April 1, 2025

Re: Route 66 Storage

99999 Central SW (Central & 98th st SW)

Conceptual Traffic Circulation Layout for DFT Approval

ENGINEER'S SEAL RONALD R. BOHANNAN P.E. #7868	ROUTE 66 STORAGE ALBUQUERQUE, NM	DRAWN BY AS
	TRAFFIC CIRCULATION LAYOUT	DATE 02/13/25
	 TIERRA WEST, LLC 5571 MIDWAY PARK PLACE NE ALBUQUERQUE, NM 87109 (505) 858-3100 www.tierrawestllc.com	SHEET # TCL
		JOB # 2022105

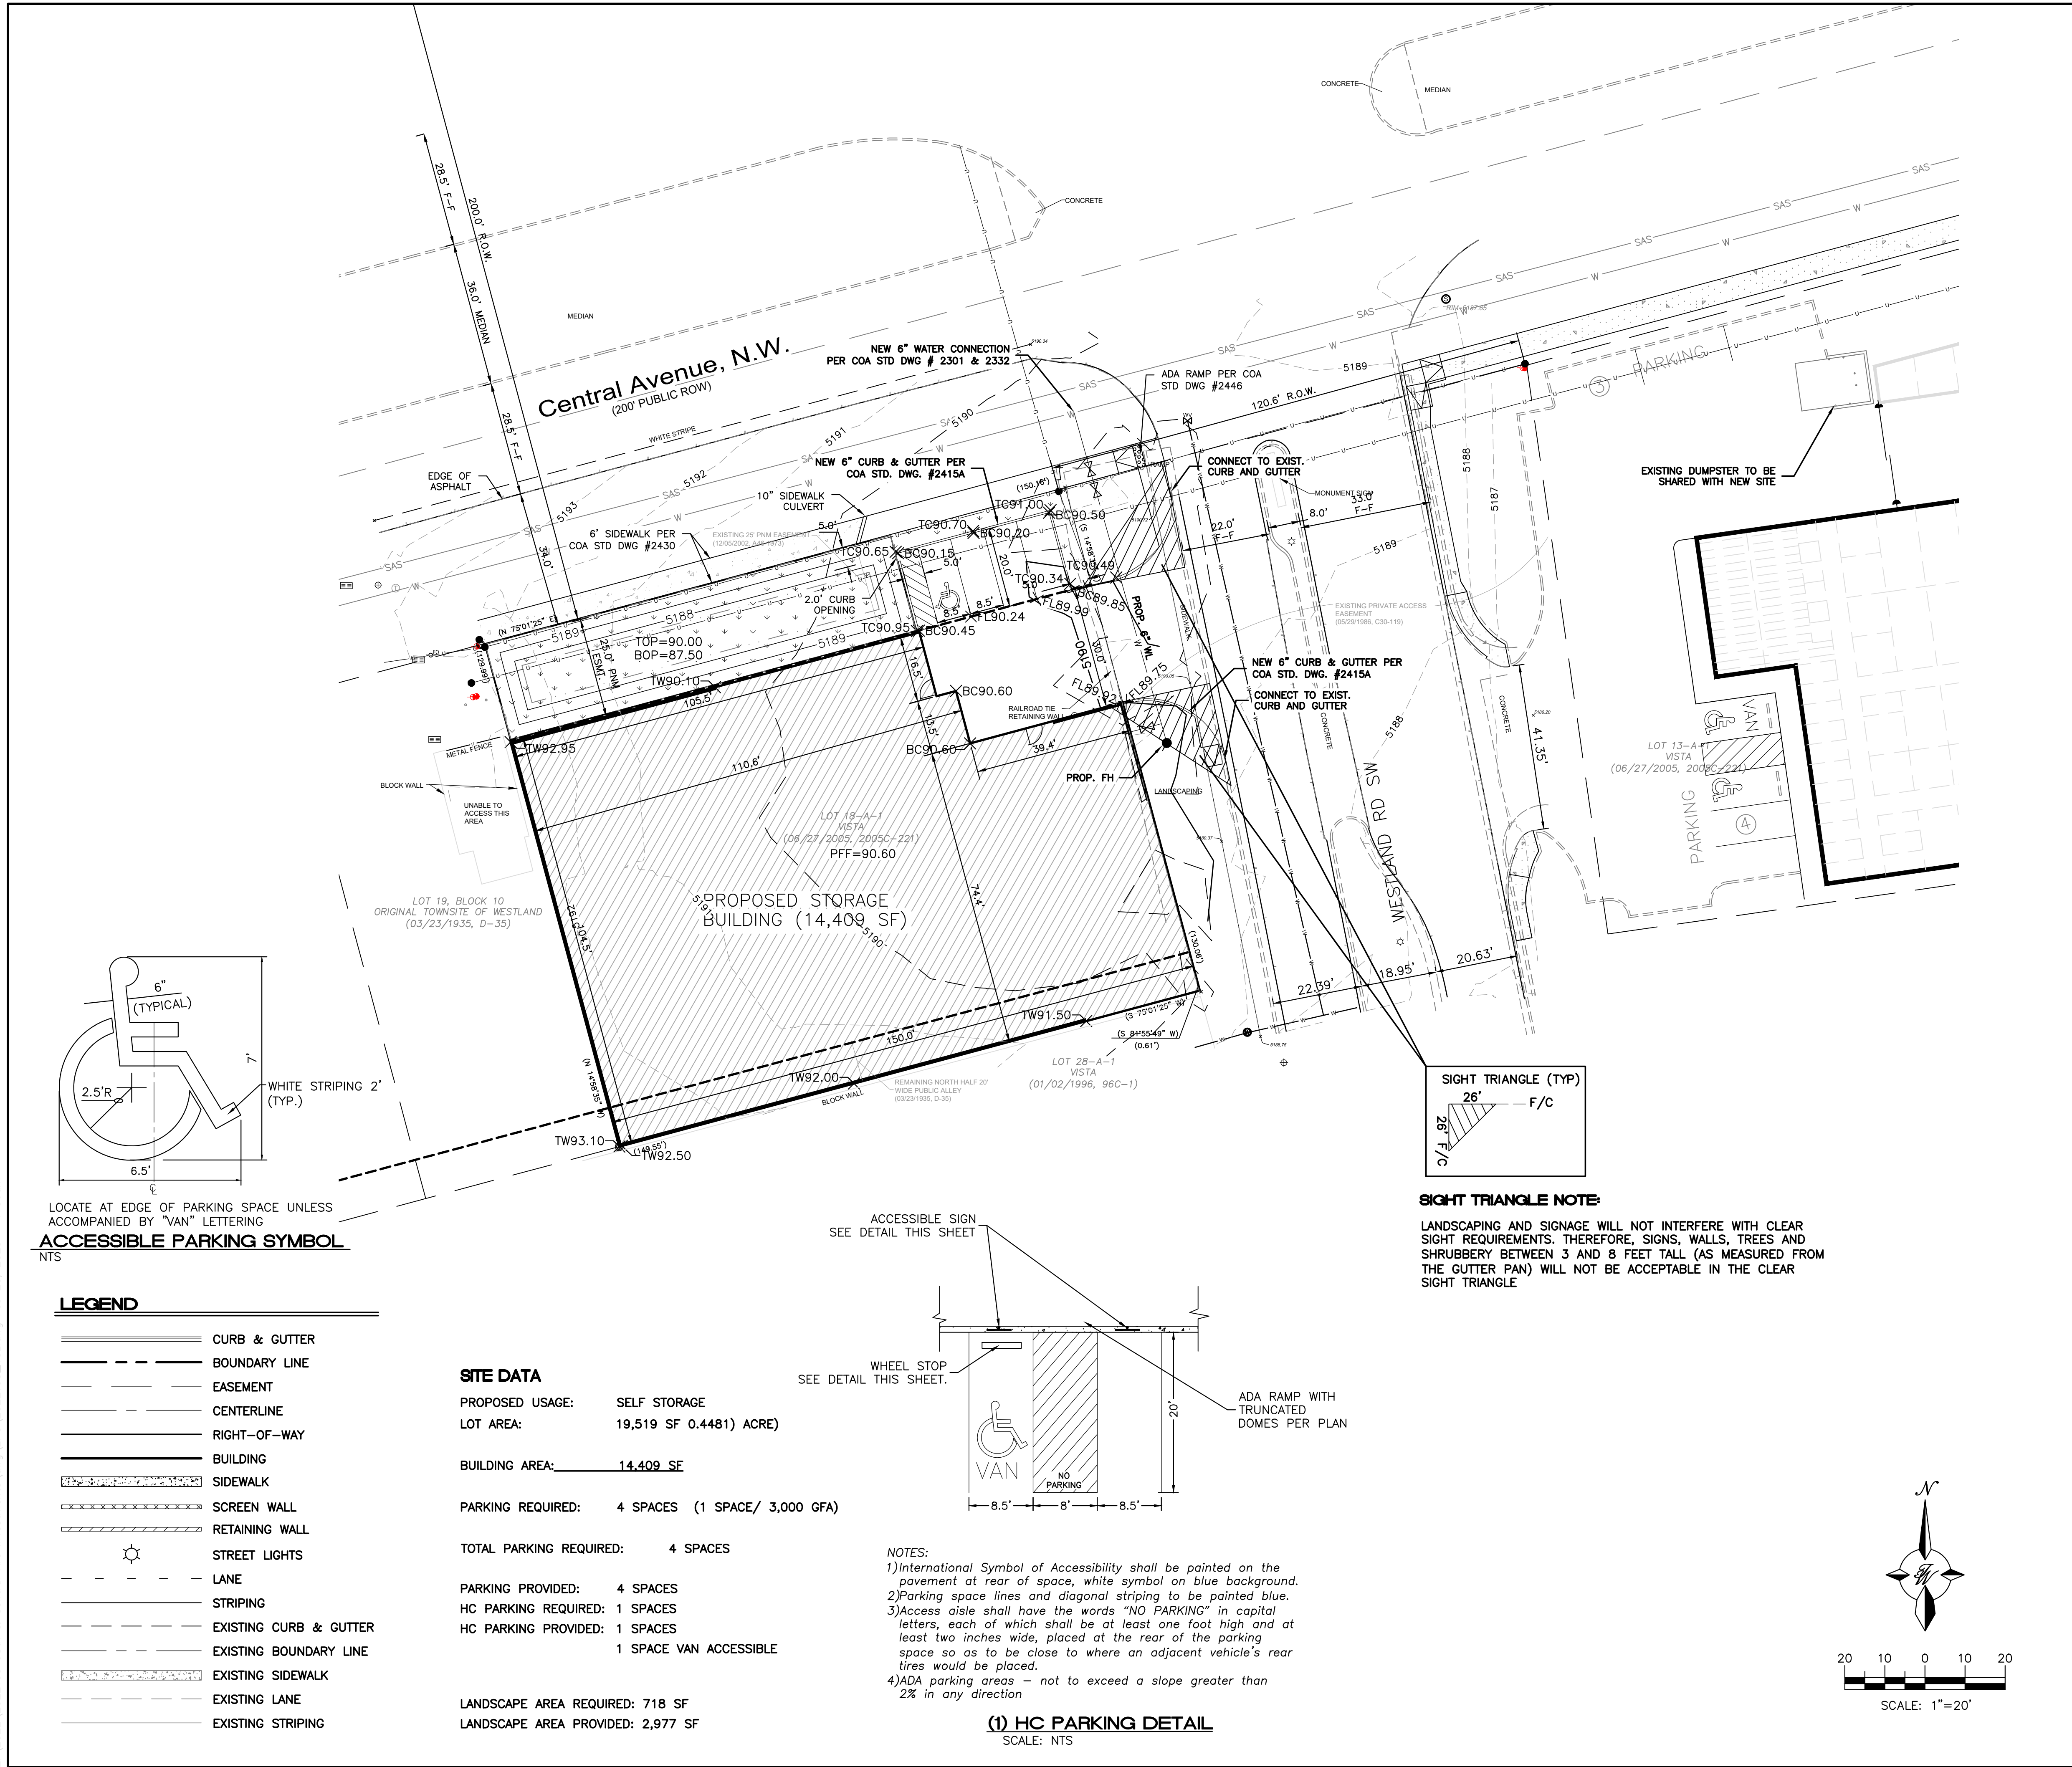
1-Van access aisle is 8 ft wide (not 5')

2-Add one Motorcycle parking space and two Bike Racks

3-Add two ADA sidewalk ramps with truncated domes at the entrance

4-Replace the COA STD. DWG #2415A by 2415C

5-Add ADA path from ADA parking to the building

6-Remove all the features from the drawing that are not TCL related.

7-Boundary line is clear

8-Show the width of sidewalk along Westland Rd. It should be a minimum of 5 ft wide
